ADDENDUM NO. 2

PUBLIC STAIRWAY **CONSTRUCTION PHASE**

BID #26-011
PAWTUCKET, RI

ISSUED: June 18, 2026

CONDUIT TRENCH PATCH

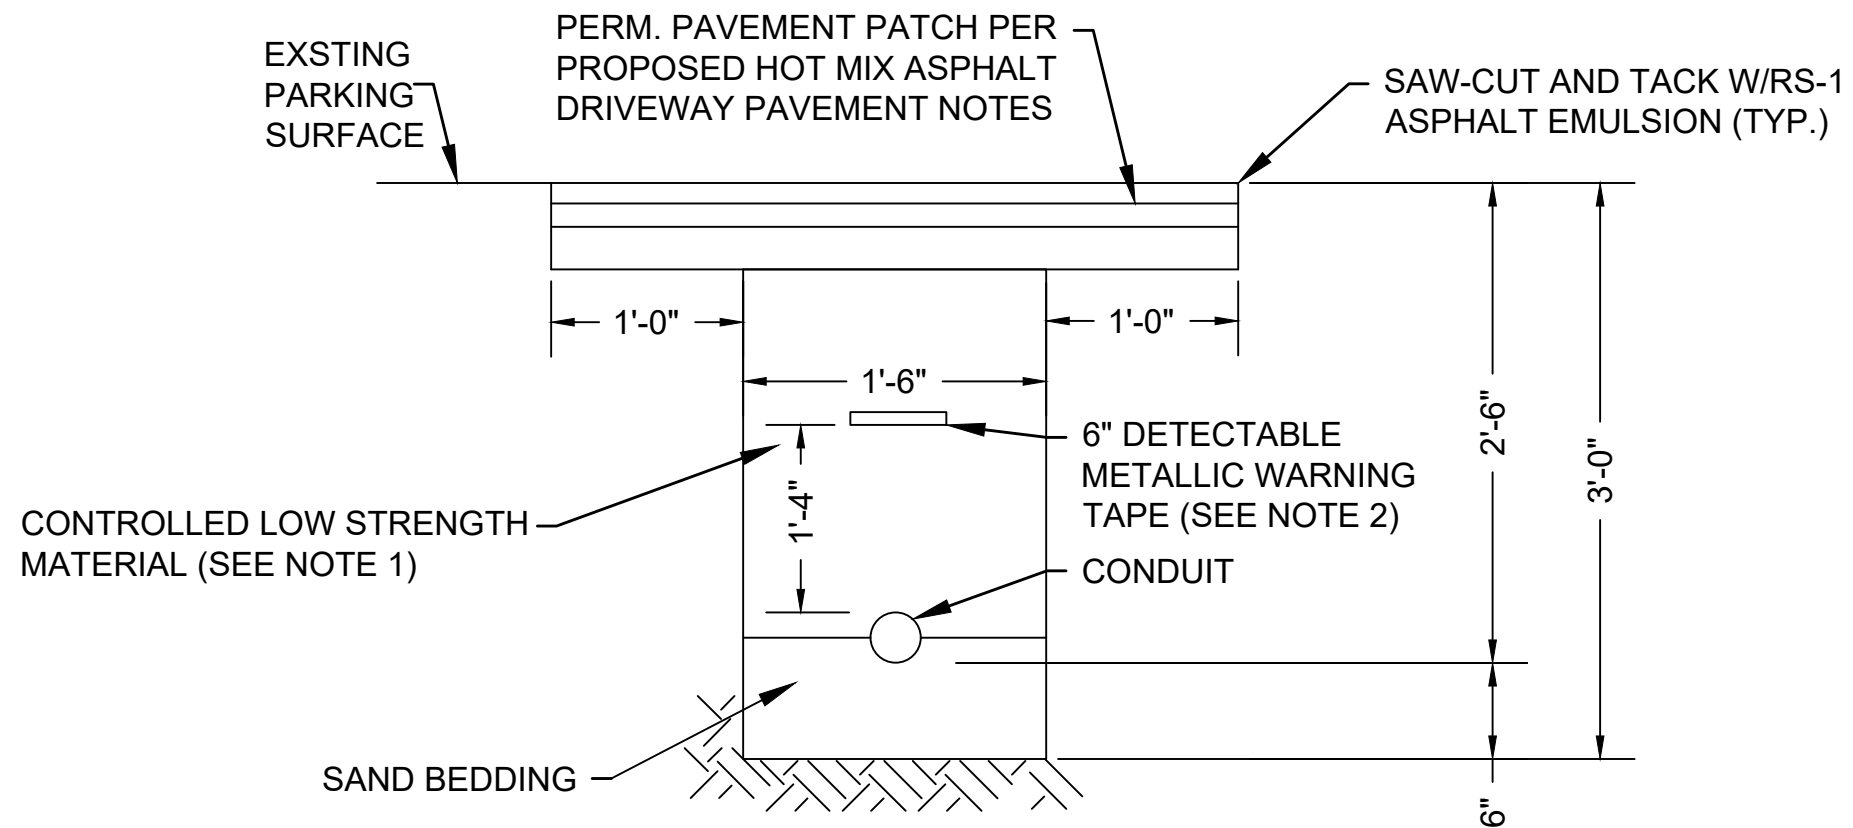
- b. Can you confirm that an initial trench patch will be sufficient repair for the runs of conduit in the parking lot area that does not receive full depth replacement?

Response: A full depth trench patch will be required for the area outside of the full depth replacement within the parking lot. A detail has been provided with this Addendum.

1. CONTROLLED LOW STRENGTH MATERIAL SHALL MEET THE REQUIREMENTS OF RHODE ISLAND DEPARTMENT OF TRANSPORTATION STANDARD SPECIFICATIONS SECTION 603.
2. WARNING TAPE SHALL BE PER CURRENT APWA STANDARDS.

CONCRETE LIGHT STANDARD BASE

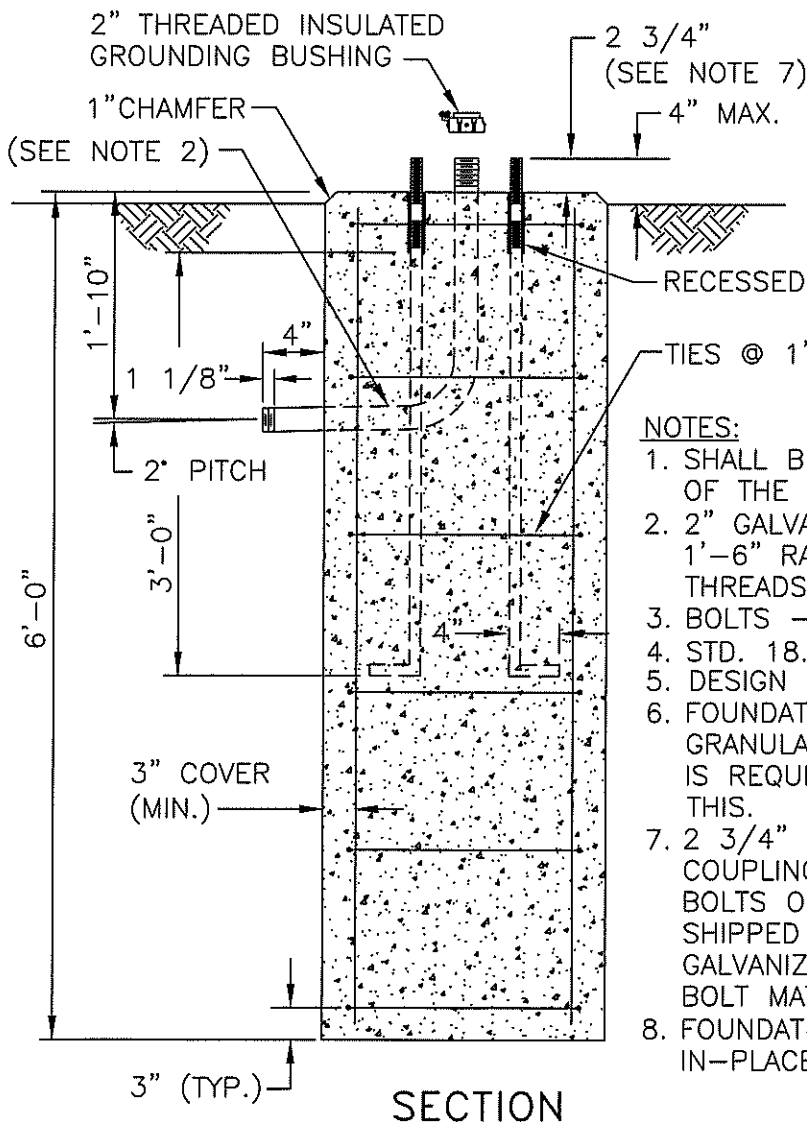
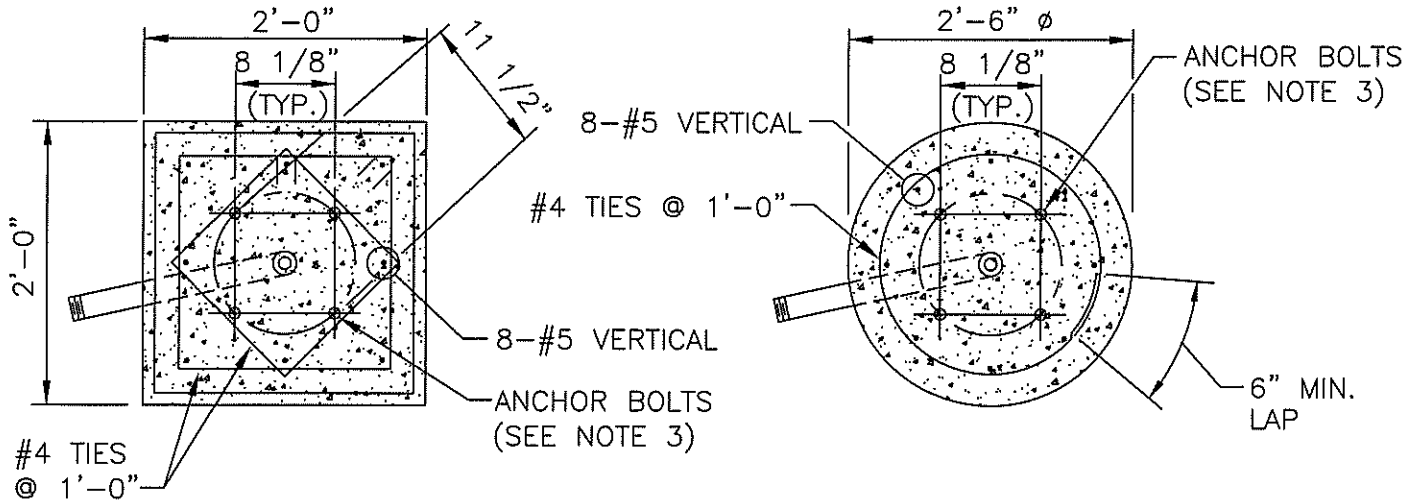
- A. Supplemental Details and Plans
 - a. Conduit Trench Patch
 - b. RI Standard Detail 18.1.0
 - c. Sheet 29

1. SHALL BE IN ACCORDANCE WITH SECTION T.08 OF THE R.I. STANDARD SPECIFICATIONS.
2. 2" GALVANIZED CONDUIT WITH 92° BEND AND 1'-6" RADIUS, PROJECTING 2 3/4" AS SHOWN. THREADS TO HAVE PROTECTOR.
3. BOLTS - (4) 1" ϕ x 3'-0" LONG WITH 4" HOOK.
4. STD. 18.3.5 TO BE USED WITH THIS STANDARD.
5. DESIGN BOLT TENSION = 30 K.
6. FOUNDATION DESIGN IS BASED ON COMPETENT GRANULAR SOIL CONDITIONS. A SPECIAL DESIGN IS REQUIRED IF FIELD CONDITIONS VARY FROM THIS.
7. 2 3/4" PROJECTION OF RECESSED BOLT COUPLINGS (RI STD. 18.3.5). ALL GALVANIZED BOLTS ON A 11 1/2" BOLT CIRCLE SHALL BE SHIPPED WITH GALVANIZED WASHERS AND GALVANIZED HEX NUTS (BOLT THREAD IS 8NC). BOLT MATERIAL IS 55,000 PSI MIN. YIELD.
8. FOUNDATIONS MAY BE PRECAST OR CAST IN-PLACE.
